KEMESS UNDERGROUND PROJECT

Application for an Amendment to Environmental Assessment Certificate #M17-01

Date: November 2017

This document represents AuRico's application to amend the Certificate pursuant to Section 19(1) of the BC *Environmental Assessment Act*. The requested amendment would address the following changes to Schedule A (Certified Project Description; CPD) of the Certificate:

Figure 2.1-1

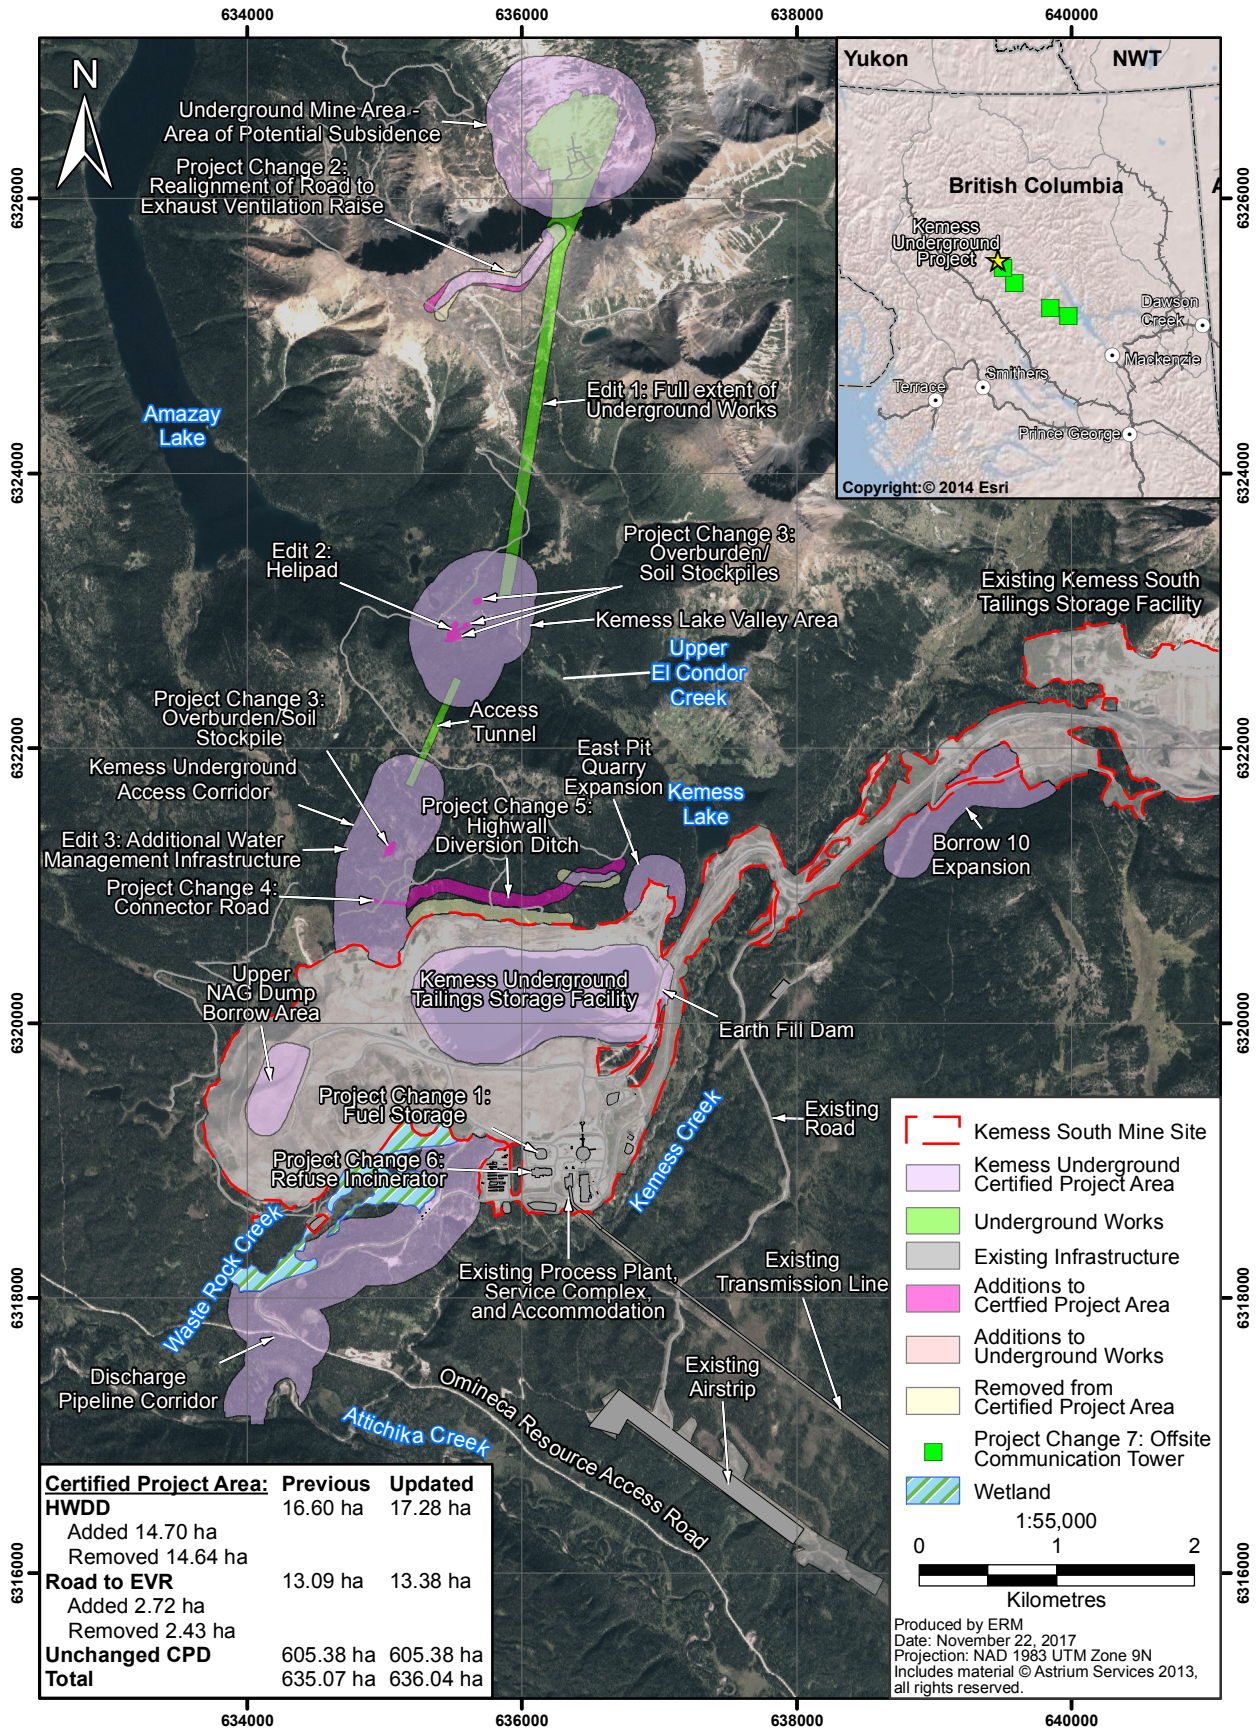
An access road will provide access to the exhaust ventilation raise above the underground workings (Section 5.8.2 of the EAC Application). The road is approximately 6,150 m in length, originating in the Kemess Lake Valley Area. Most of the road is an upgrade of an existing exploration road in order to accommodate single lane traffic. Approximately 1,250 m of the northern segment of the road is new construction.

Following further ground-truthing, the alignment of the northern segment of the road has been modified to locate the road in an area that is better suited to the local topography and outcrop conditions. This change will improve construction and operating efficiencies, and reduce maintenance requirements. Approximately 250 m of the road lies outside of the CPA, covering an area of approximately 0.25 ha (average 10 m in width).

The EAC Application does not identify a road connecting the Kemess Underground Access Corridor to the HWDD. Previous mine planning assumed that a maintenance road would be located on the upslope berm of the HWDD. A new 250 m long road is now proposed to connect the Kemess Underground Access Corridor to the HWDD. The road will also extend along the length of the HWDD for maintenance purposes. This change will provide a more efficient route for the movement of construction and maintenance equipment, and personnel between the HWDD and the Kemess Underground Access Corridor. The proposed road is located in an area that was assessed in the EAC Application and falls within the CPA (Figure 2.1-1).

To improve the management of non-contact water around the KUG TSF and to enhance non-contact water discharge to Waste Rock Creek, modifications to the HWDD alignment indicated in the CPD are proposed to create one continuous ditch that incorporates the upper East ditch. Additional field

surveys determined that the HWDD should be placed further upslope to an area that is more geotechnically stable. Approximately 1.5 km of the length of the modified HWDD lies outside of the CPA (Figure 2.1-1), and covers an area of approximately 1.5 ha (average 10 m in width).

Figure 2.1-2
Proposed Location of Microwave Towers

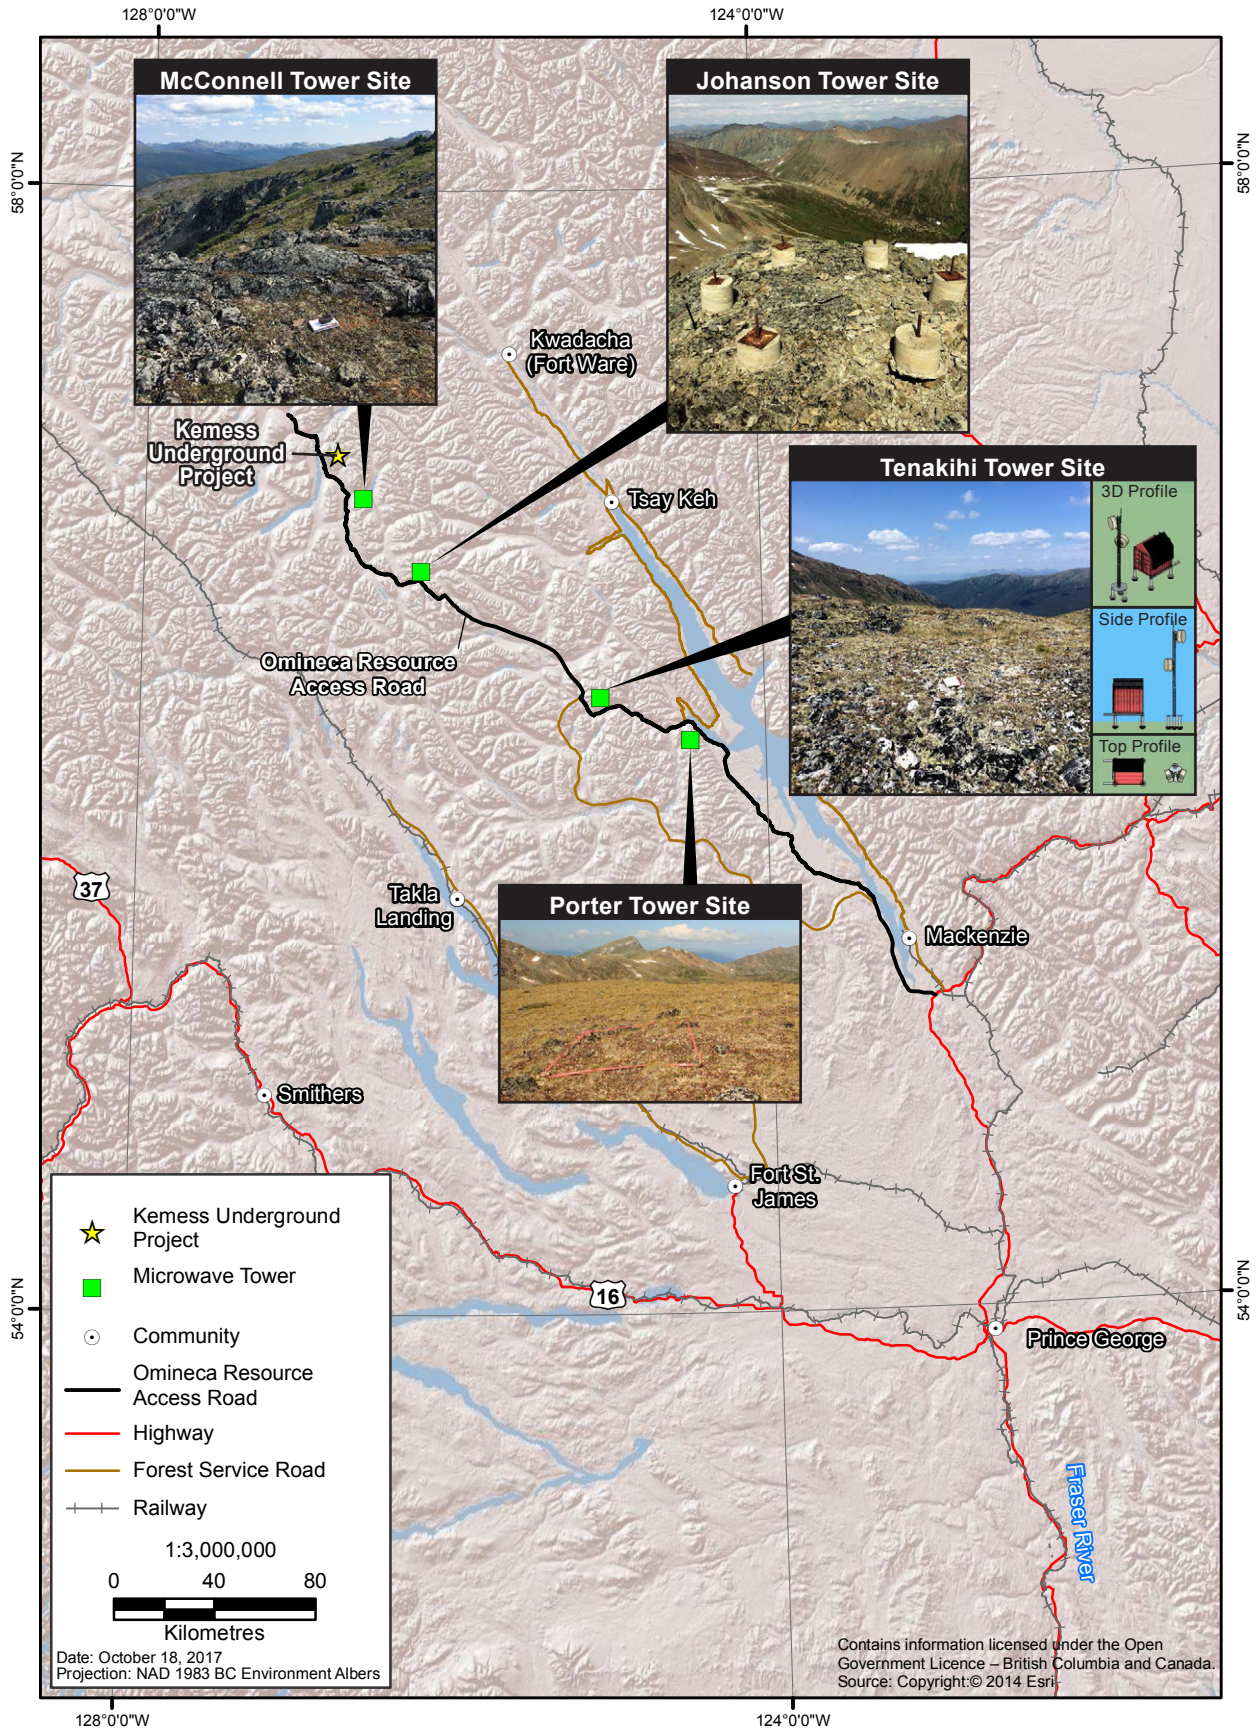
The EAC Application did not include new or different communication infrastructure from the existing communications system used for the Kemess South Mine. Four microwave towers are proposed to improve site communications and for safety reasons. The towers would be located on mountain peaks between Mackenzie and the mine site (Figure 2.1-2). The footprint of each tower is anticipated to be less than 10 m² (less than 0.001 ha). The towers would be installed and maintained by helicopter. The frequency of tower maintenance would be less than once per month. The towers are located outside of the CPA and areas assessed in the EAC Application.

Figure 7.1-1
Location of Microwave Towers in relation to Ungulate Winter Range

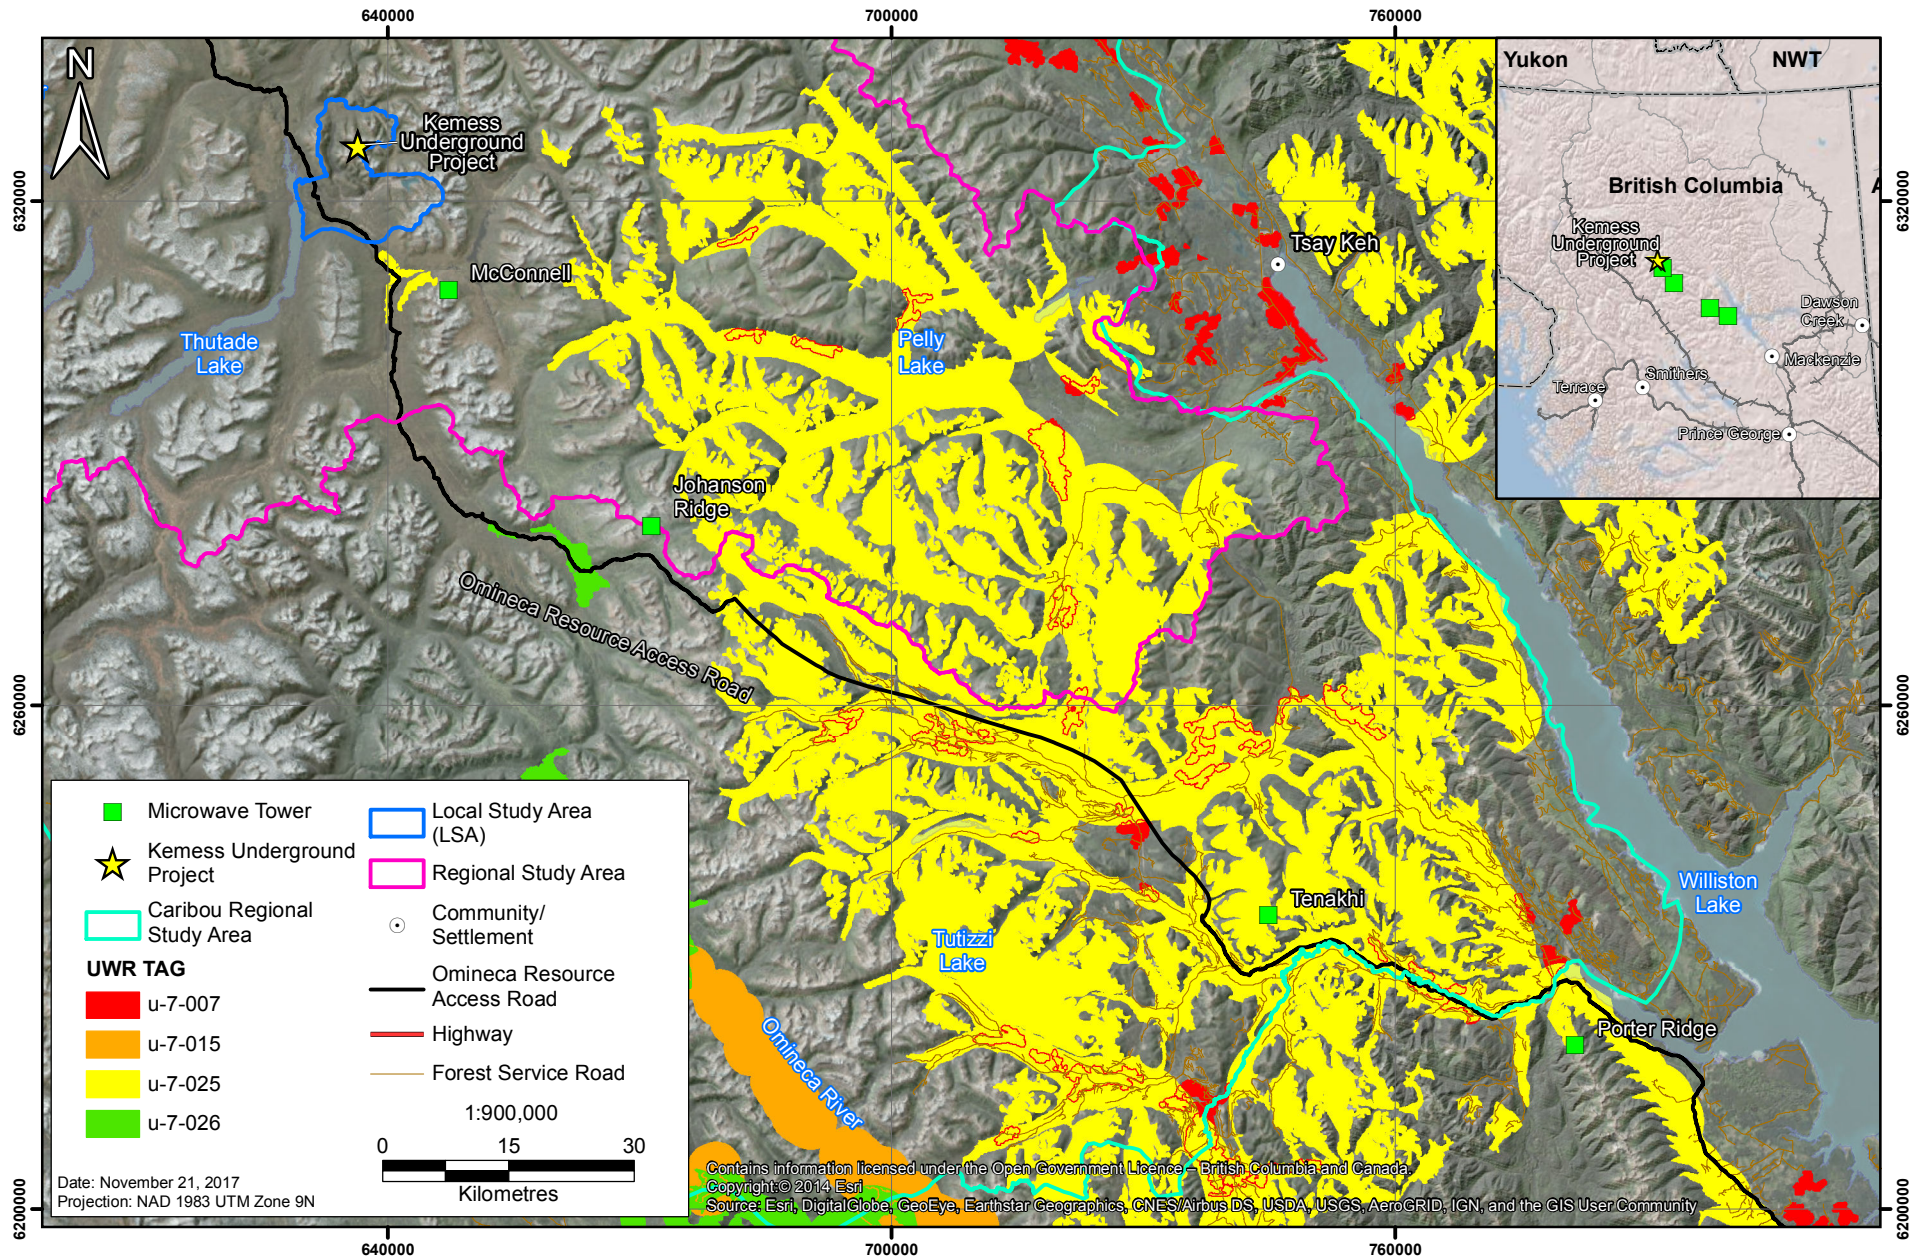
The use of helicopters to install and maintain the four microwave towers has the potential to adversely affect woodland caribou due to sensory disturbance, as three of the four towers are located within ungulate winter range (UWR) U-7-025 for northern caribou (Figure 7.1-1).

The WMMP provided with the MA/EMA Application includes measures to mitigate effects from aircraft on mountain goats. These measures can be applied to mitigate effects associated with aircraft on woodland caribou. The following measures are proposed to mitigate potential effects on woodland caribou:

- use topographic barriers to separate helicopters from caribou;
- remain below caribou if possible;
- avoid flying directly towards, hovering near, or landing near caribou;
- maintain a 400 m vertical separation between helicopters and caribou winter range, weather permitting (FLNRO 2014);
- prioritize helicopter access to tower sites during low risk caribou windows (FLNRO 2014):
 - low risk: July 16 to September 14; and
 - caution: September 15 to January 14;
- avoid tower sites between January 15 and July 15 to minimize disturbance to caribou and wolverine, if possible.

Map 1

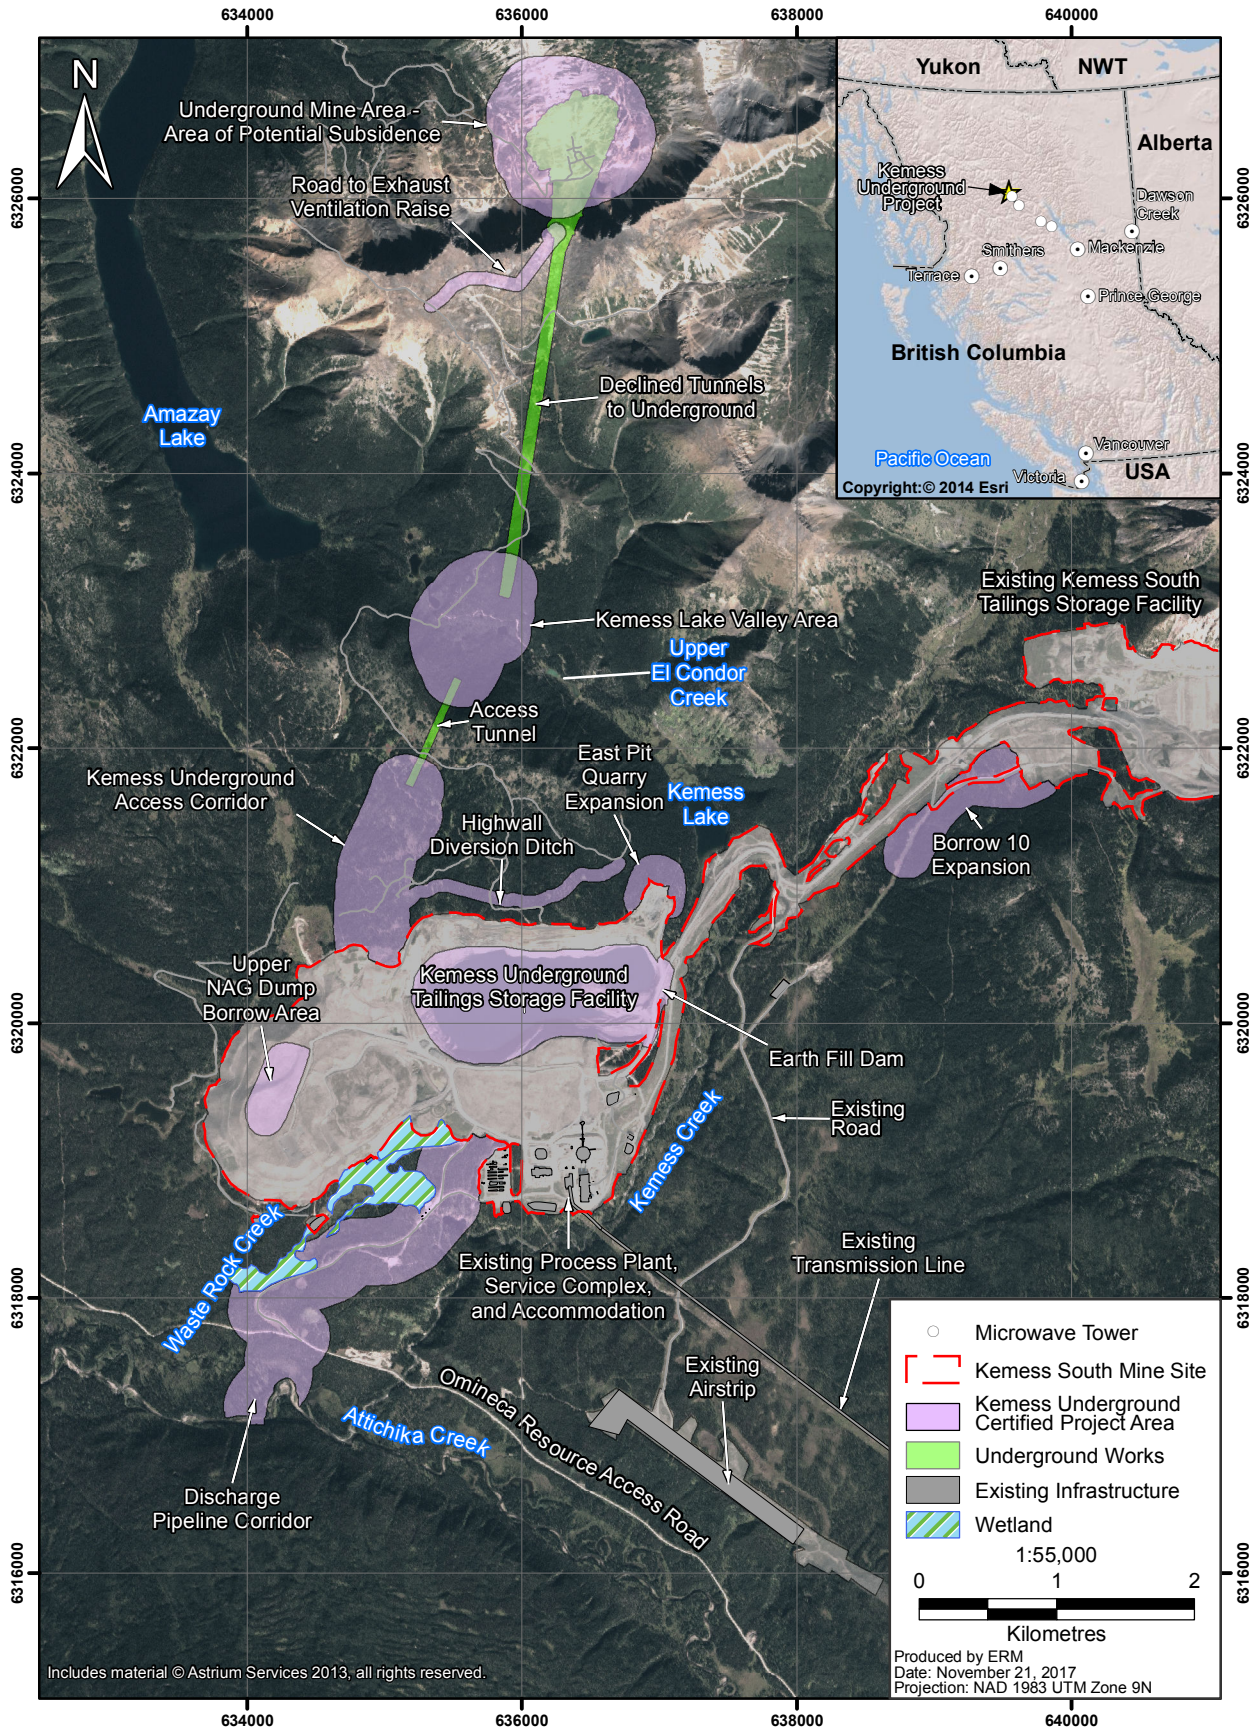
7. Replace Map 1, Overall Layout of the Kemess Underground Project, with Map 1 attached in Appendix A of this Amendment Application.
8. Replace Map 2, Kemess Underground Project North Detail, with Map 2 attached in Appendix A of this Amendment Application.
9. Replace Map 3, Kemess Underground Project East Detail, with Map 3 attached in Appendix A of this Amendment Application.
10. Replace Map 4, Kemess Underground Project South Detail, with Map 4 attached in Appendix A of this Amendment Application.
